PIC18F45J10 Family Silicon Errata and Data Sheet Clarification

Data Sheet Clarifications

The following typographic corrections and clarifications are to be noted for the latest version of the device data sheet (DS39682E):

FIGURE 2-3 FREQUENCY vs. ESR PERFORMANCE FOR SUGGESTED VCAP

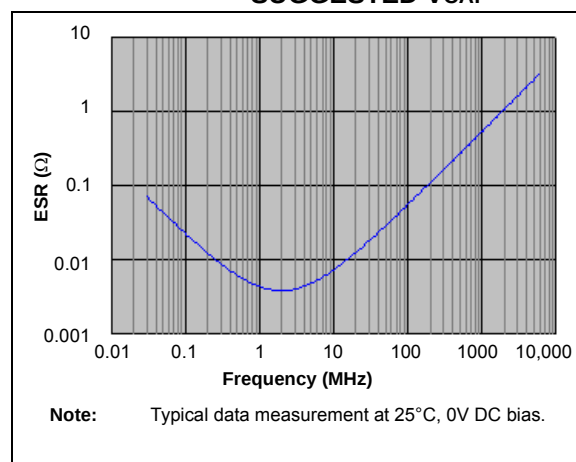
Section 2.4 Voltage Regulator Pins (VCAP/VDDCORE) has been replaced with a new and more detailed section. The entire text follows:

When the regulator is enabled (F devices), a low-ESR ($< 5\Omega$) capacitor is required on the VCAP/VDDCORE pin to stabilize the voltage regulator output voltage. The VCAP/VDDCORE pin must not be connected to VDD and must use a capacitor of 10 μF connected to ground. The type can be ceramic or tantalum. Suitable examples of capacitors are shown in [Table 2-1](#). Capacitors with equivalent specifications can be used.

Designers may use [Figure 2-3](#) to evaluate ESR equivalence of candidate devices.

FIGURE 2-4 DC BIAS VOLTAGE vs. CAPACITANCE CHARACTERISTICS

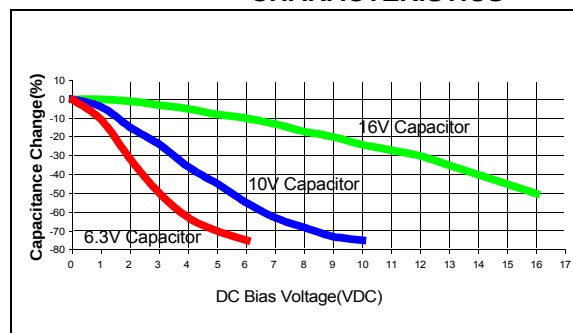
In addition to temperature tolerance, the effective capacitance of large value ceramic capacitors can vary substantially, based on the amount of DC voltage applied to the capacitor. This effect can be very significant, but is often overlooked or is not always documented.

A typical DC bias voltage vs. capacitance graph for 16V, 10V and 6.3V rated capacitors is shown in Figure 2-4.

When selecting a ceramic capacitor to be used with the internal voltage regulator, it is suggested to select a high-voltage rating, so that the operating voltage is a small percentage of the maximum rated capacitor voltage. For example, choose a ceramic capacitor rated at 16V for the 2.5V core voltage. Suggested capacitors are shown in Table 2-1.
